PLANNING COMMISSION MEETING

LOCATION: TOWNSHIP ANNEX, 7527 HIGHLAND ROAD, WHITE LAKE, MI 48383
THURSDAY, JULY 20, 2023 – 7:00 PM

RE: Sunset Cove Condominiums- Preliminary Site Plan Review – 3rd Review

RE: Sunset Cove
Preliminary Site Plan and Special Land Use – Review #3

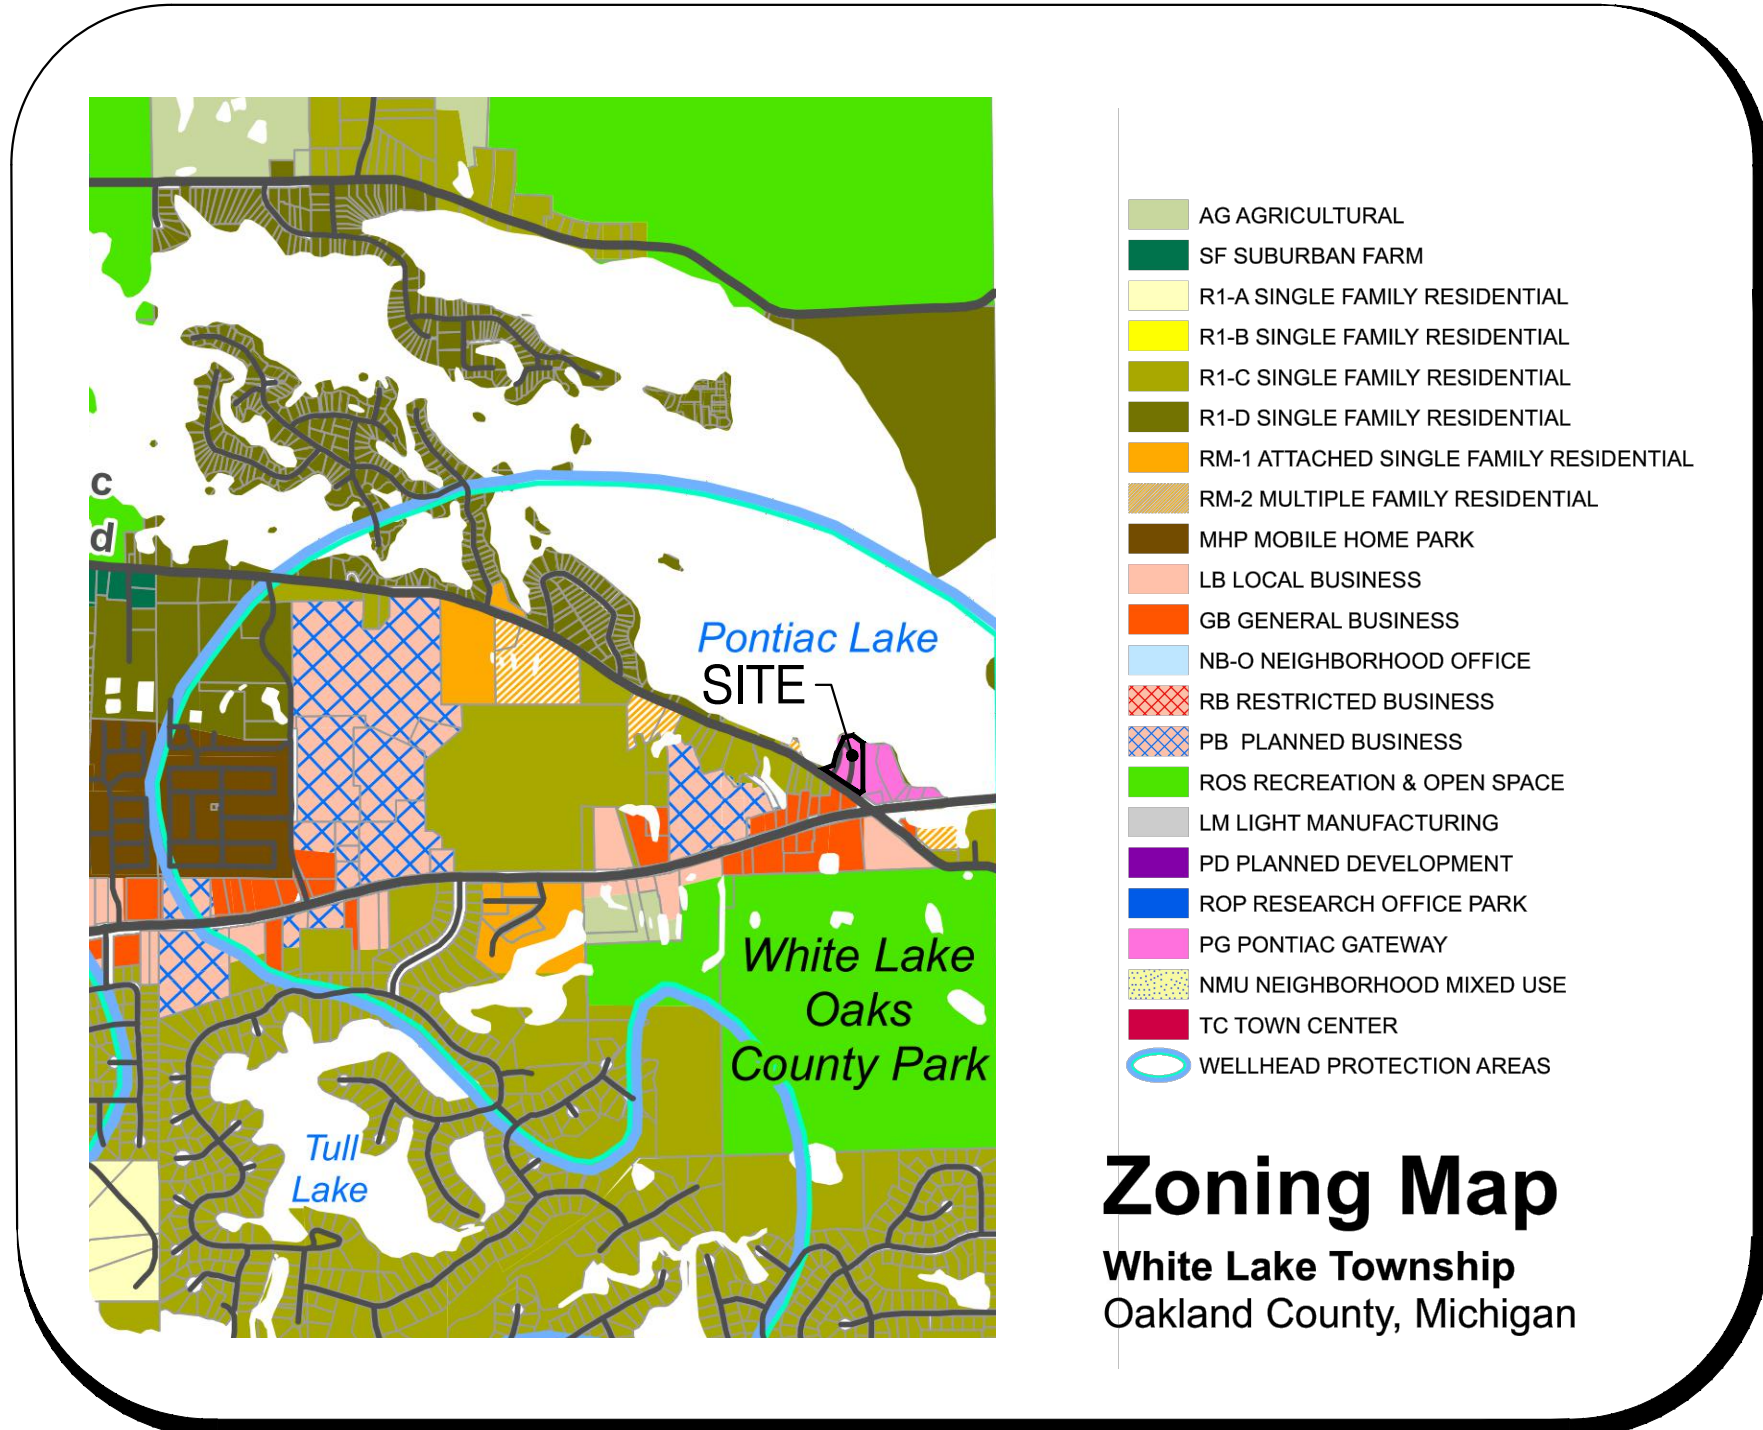
- a. Suppression, alarm, FDC, Standpipe, Flow Indication, and Knox box requirements will be addressed during the construction plan review phase.

SCALE: 1" = 30' PROJECT ID: DET-220180
 TITLE:
STORMWATER MANAGEMENT PLAN
 DRAWING:
C-5

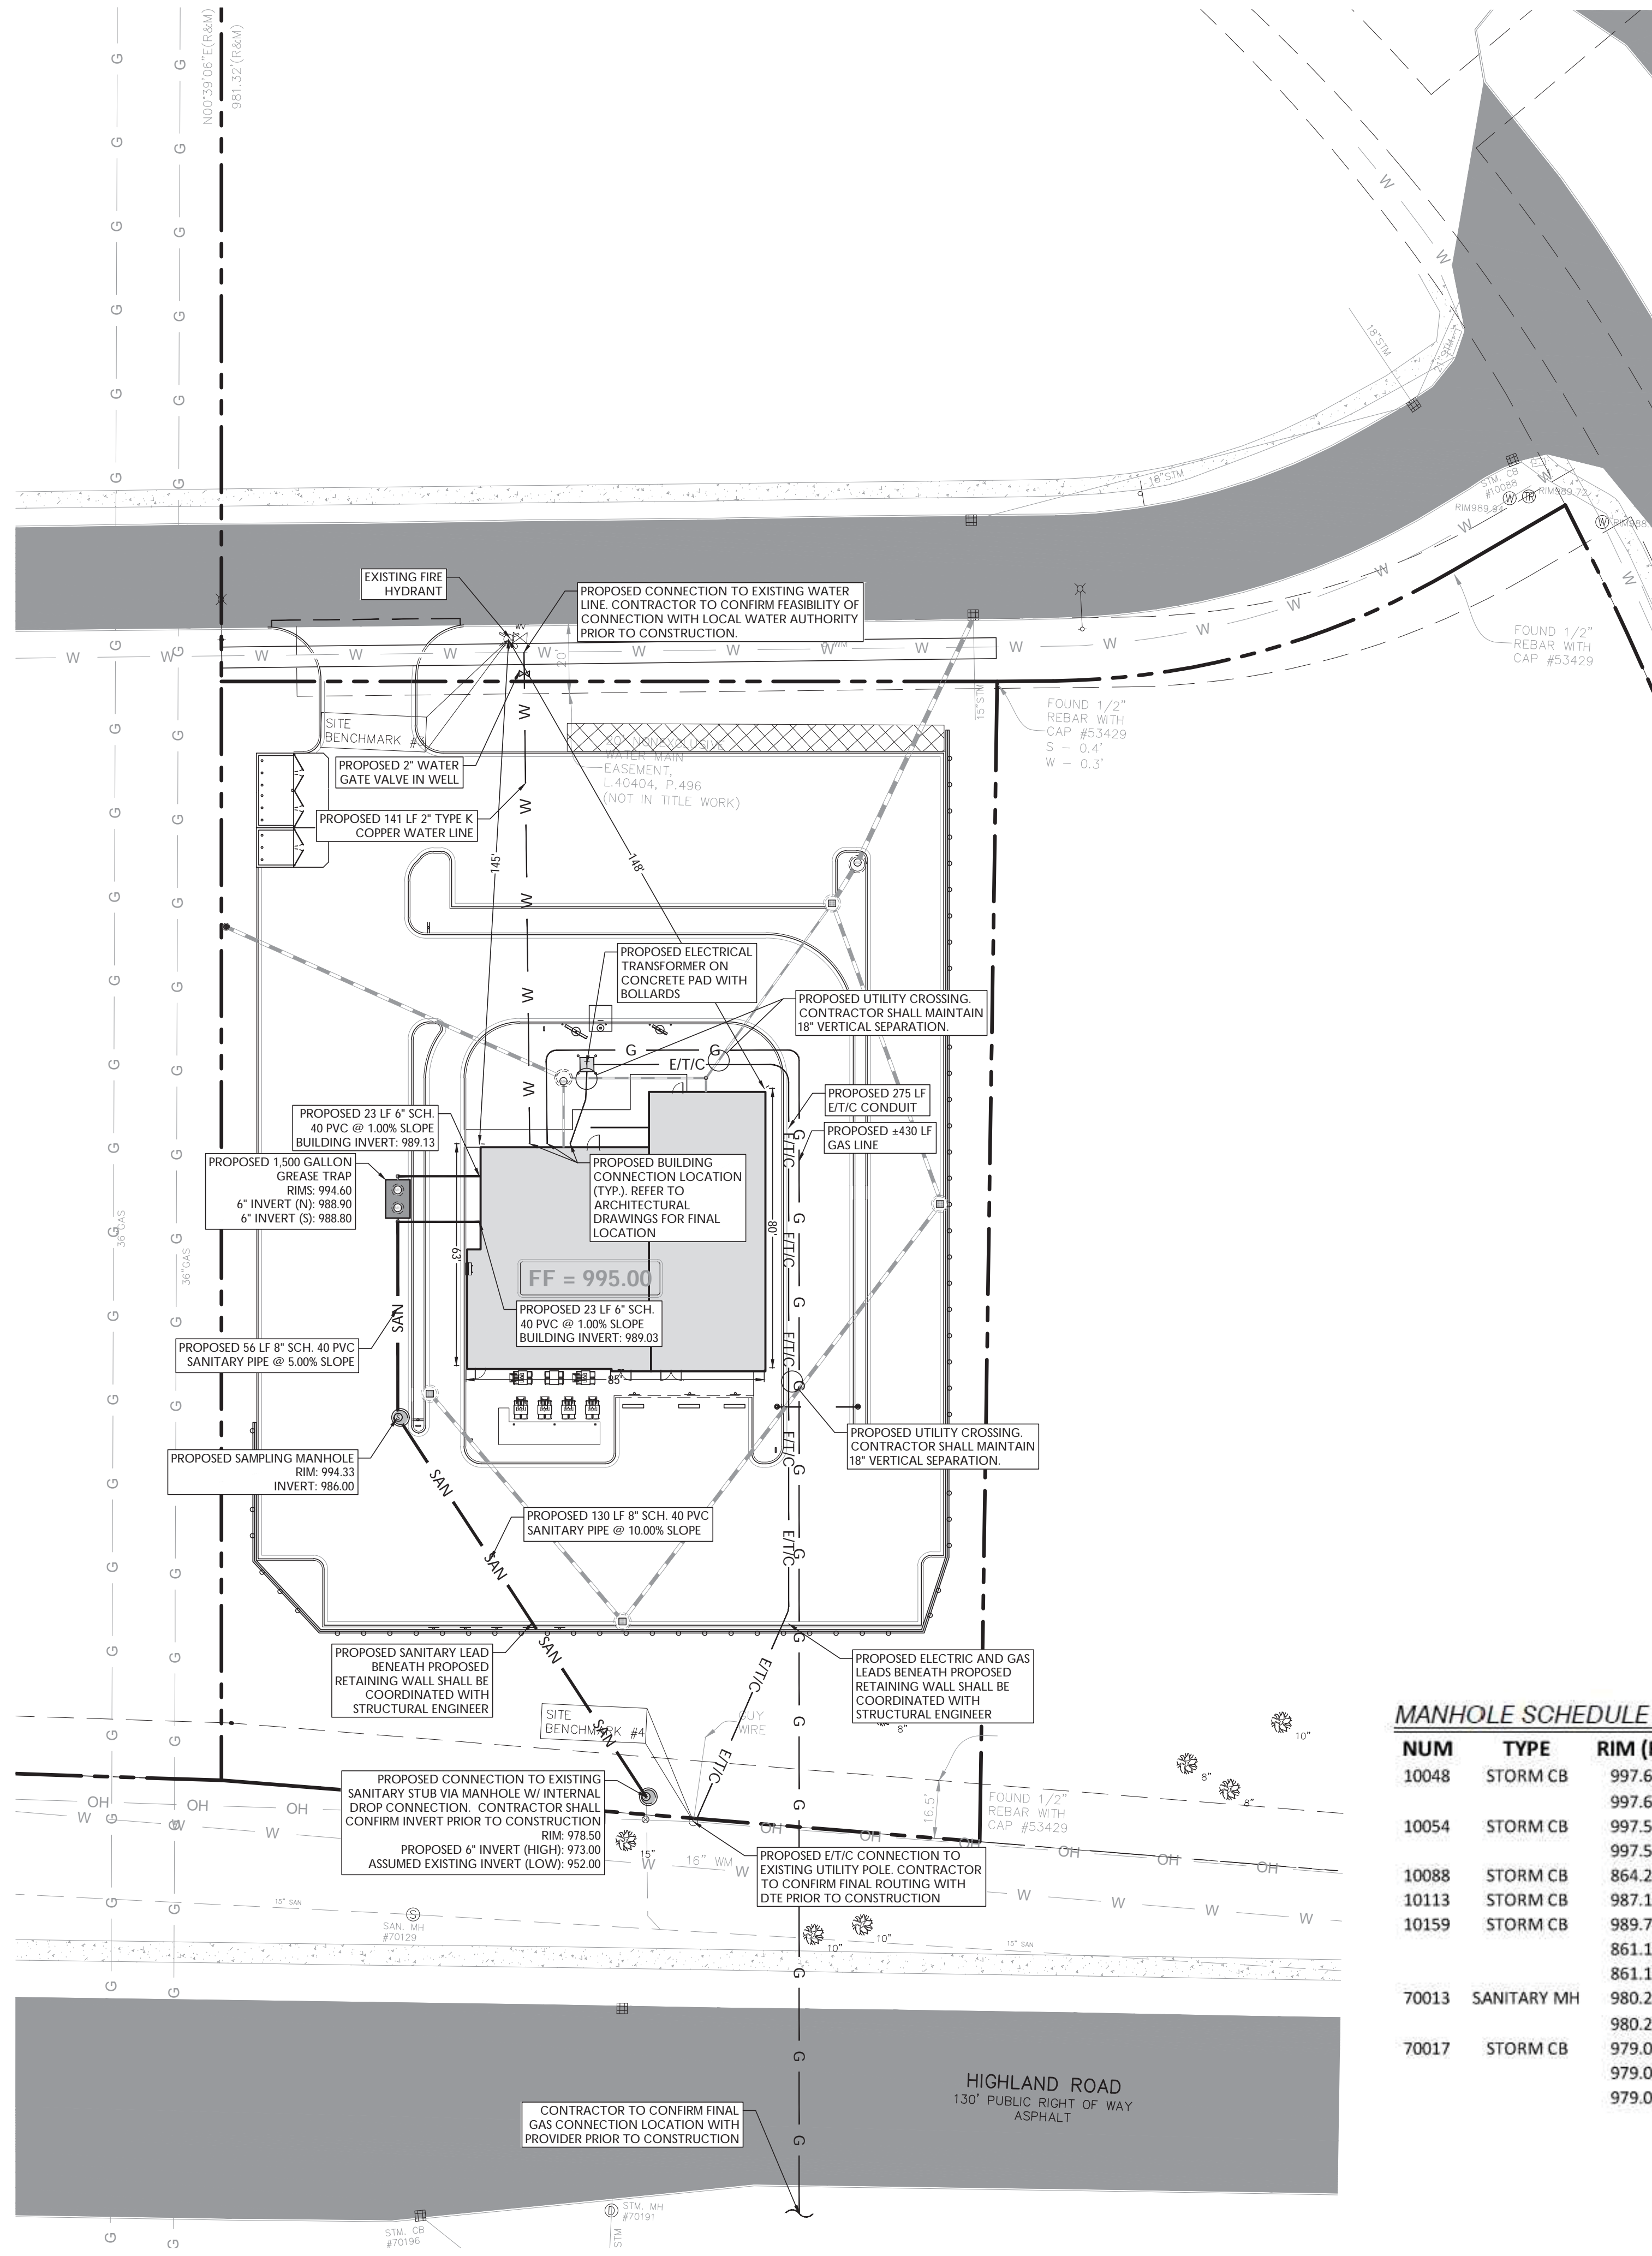
- d) *The existing rim elevation for storm sewer structure number 10048 as shown on the manhole schedule on the plan sheets and in plan view (shown as 992.35') on Sheet C-5 shall be verified. Per the manhole schedule, the rim elevation is 997.66' and it is 998.70' per Meijer Storm Sewer A/B plan dated 02/21/2006. Comment partially addressed. A copy of the Meijer storm sewer plan has been attached. Please update the rim elevation. **Comment addressed. Rim elevation has been updated per the Meijer Storm Sewer as built plan.***
